PLANNING & ZONING COMMISSION

Regular Meeting Agenda
CITY OF PARKVILLE, MISSOURI
Tuesday, January 9, 2024 5:30 PM
City Hall Board Room

<u>Agenda Item:</u>	5.A
<u>Proposal:</u>	Application for Preliminary Development Plan for Chase Bank, a financial institution on Lot 4 of APEX Plaza, generally located at the northwest corner of Highway 45 and Melody Lane in Parkville, MO 64152.
<u>Staff Recommendation:</u>	Approval (with conditions)
<u>Case No:</u>	PZ 2023-36
<u>Applicant:</u>	Carlos Iglesias, Cumulus Design
<u>Owners:</u>	Daniel Carr, CBC Parkville 4, LLC
<u>Location:</u>	9000 NW Highway 45, Generally at the northwest corner of 45 Hwy and Melody Ln.
<u>Zoning:</u>	"B-4-P" Planned Business District
<u>Parcel #s:</u>	Platte County parcel no. 20-6.0-23-400-005-002.000
<u>Exhibits:</u>	A. This Staff Analysis B. Application for Preliminary Development Plan C. Subject Property Area Map D. Preliminary Development Plans for Chase Bank (prepared by Cumulus Design; dated November 2, 2023) E. Application Narrative (Submitted by Applicant) F. Additional exhibits as may be presented during the meeting

SITE PLAN
CHASE BANK – 6408 NW MELODY LN
PARKVILLE, MO 64152
PLATTE COUNTY

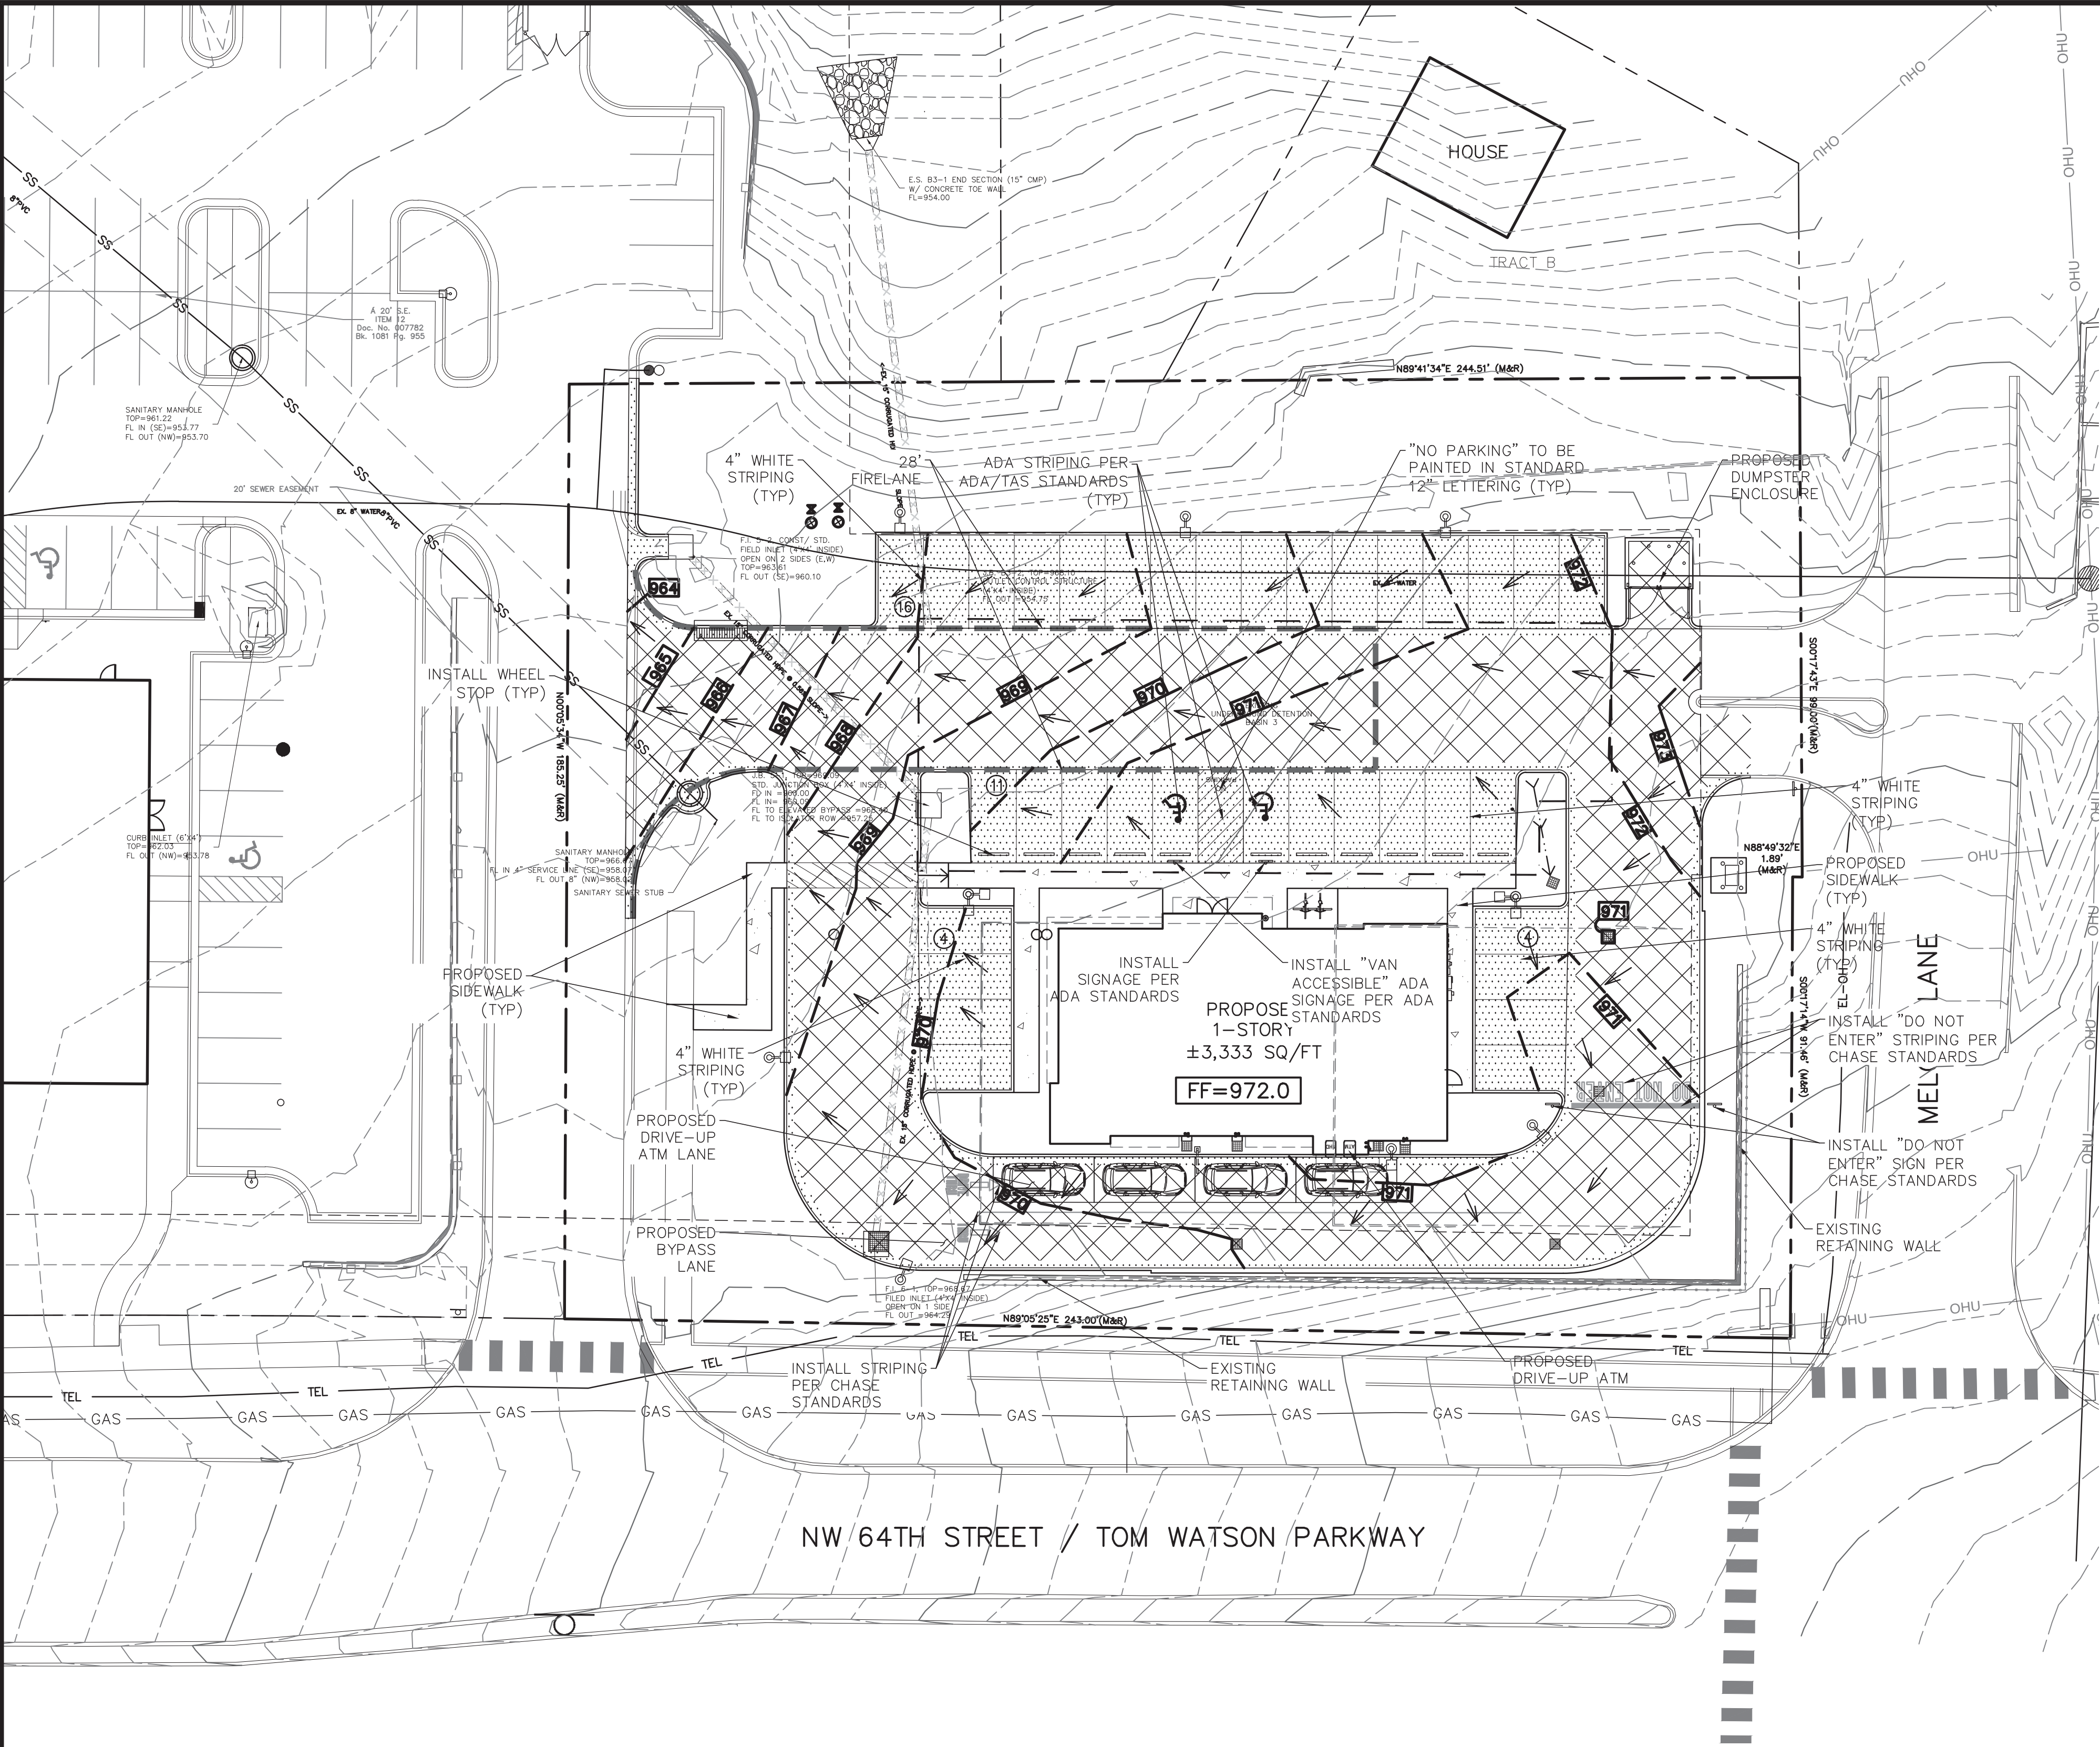
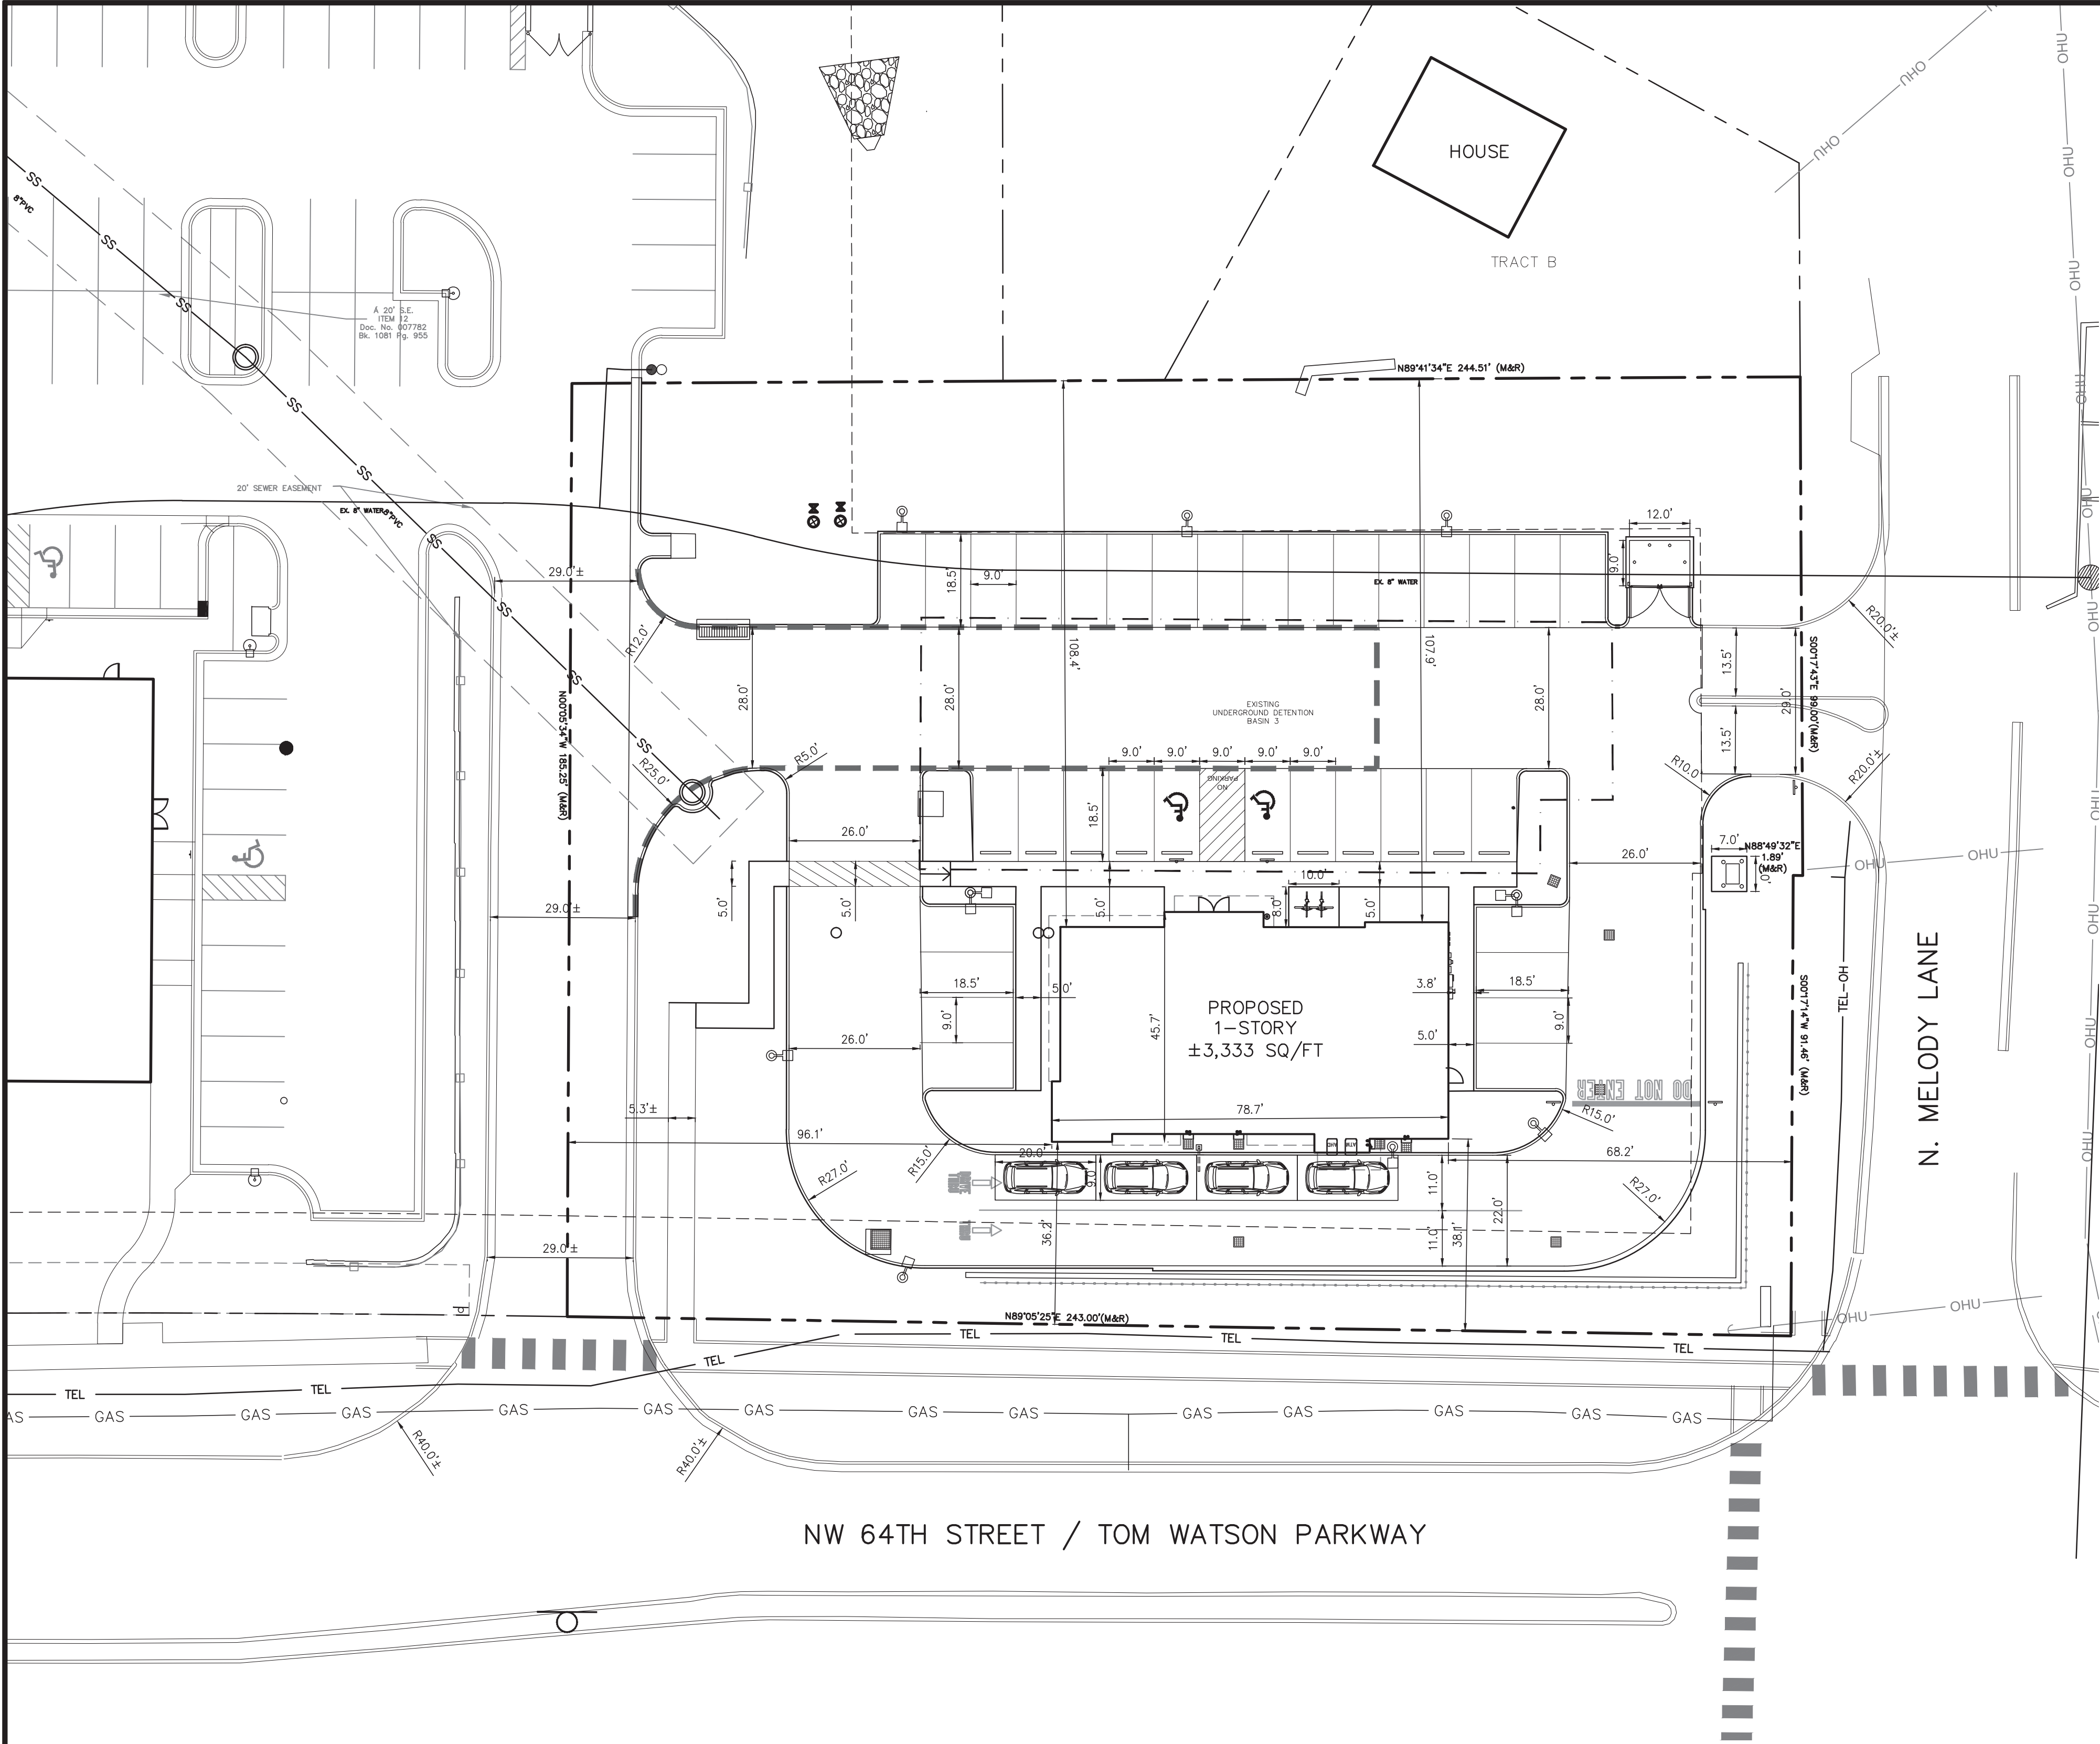
Flexibility is requested from two development standards. The first is the applicant is proposing to exceed the parking maximum. Table 408-5 provides required parking counts for development, noting 3 spaces required per 1,000 sq. ft. of building area. A 3,333 sq. ft. building would require 10 parking spaces. The applicant has provided 35 parking spaces which is greater than the allowed parking maximum of 12. Staff finds this appropriate as it is maintaining the original APEX Plaza plan while also reducing the degree of non-conformance (42 parking stalls in the 2017 plan compared to 35 parking stalls in the proposed plan).

Staff recommends approval of the preliminary development plan for Chase Bank, subject to the following conditions:

1. Approval is based on the representations of the drawings presented as part of this application and does not waive any requirement or development standard contained within the Municipal Code.
2. Prior to Final Development Plan approval, the applicant shall install all stormwater management infrastructure as required by Public Works.
3. Any other conditions the Planning and Zoning Commission determines are necessary.
